BULLETIN # 7

PROJECT: Harrison Recreation & Community Center – PHASE 1
Harrison, NY

RE: Additional Electrical Conduit- Reference ASK-05

Sheet Title
AMENDED WATER & FIRE SERVICE & HDS-2 LOCATIONS

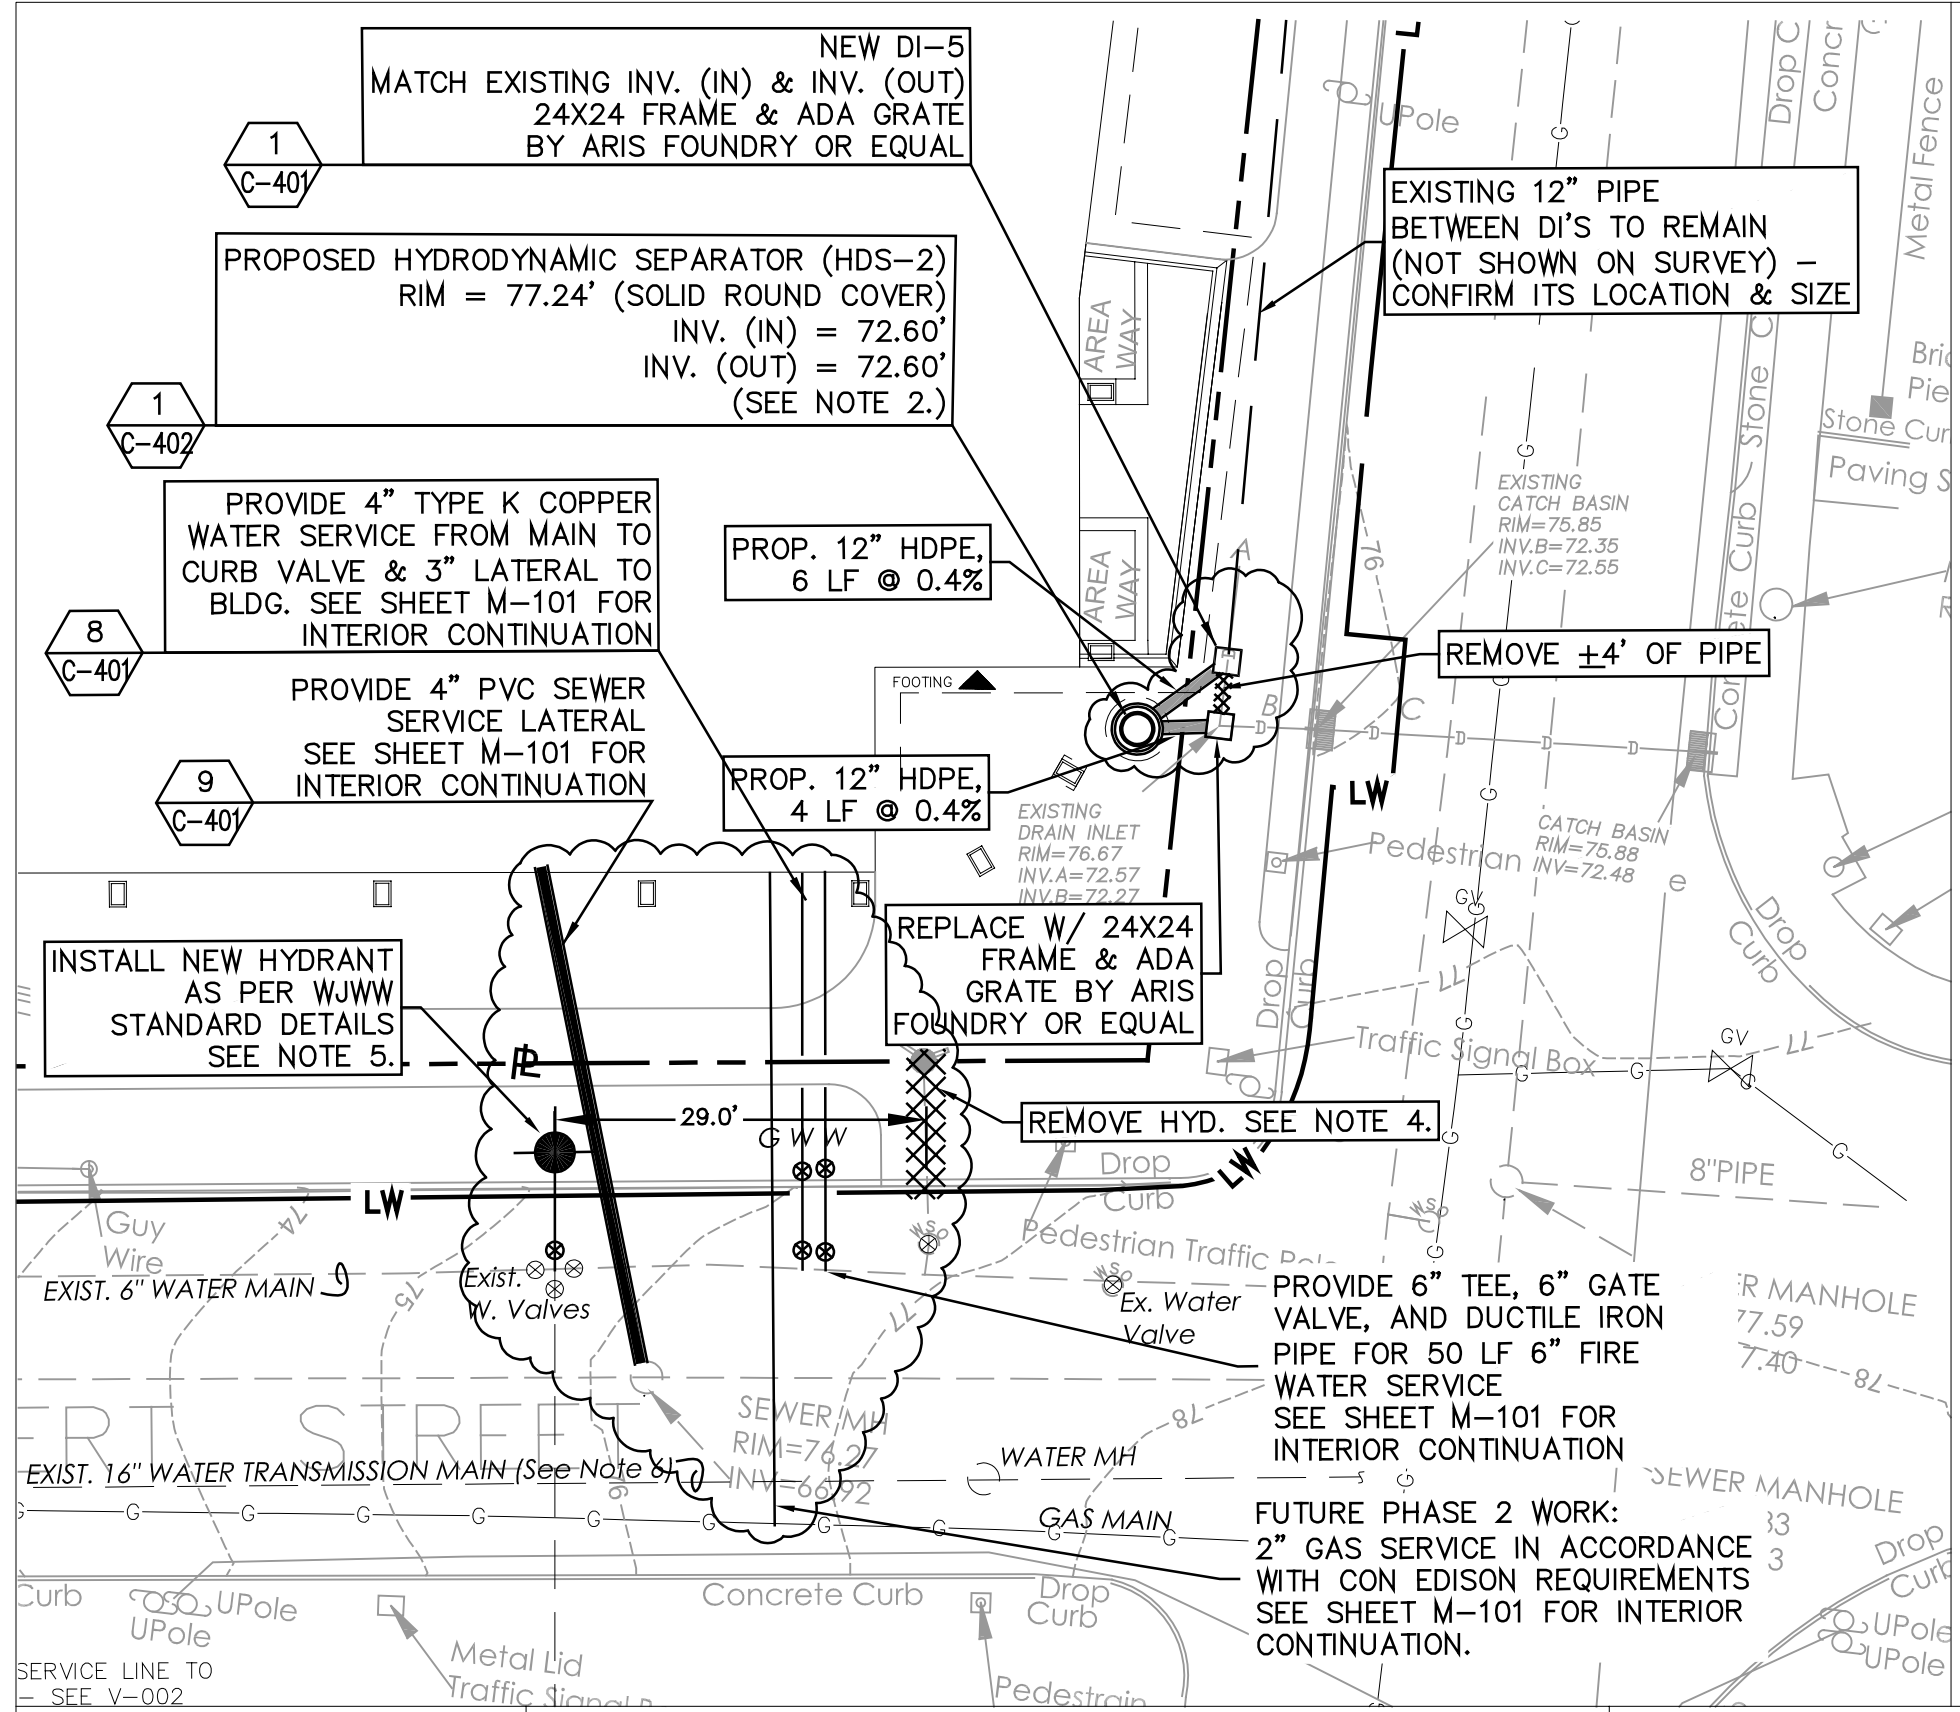
Due to permit review comments by Westchester Joint Water Works relocate HDS-2, add DI-5 and additional piping as shown on attached ASK-05. There is an existing 12" pipe north of the new DI-5. The existing pipe is currently noted to confirm the location and size. Please provide an alternate price to replace this pipe from DI-5 to the existing to remain drain inlet to the north (Rim=76.98).

Note that the water service from the main to the curb valve has been revised to a 4" diameter from a 3" diameter pipe. It remains a 3" pipe after the curb valve. Also note that the gas service and domestic water service lines have been flipped so that the gas service is south of the water service.
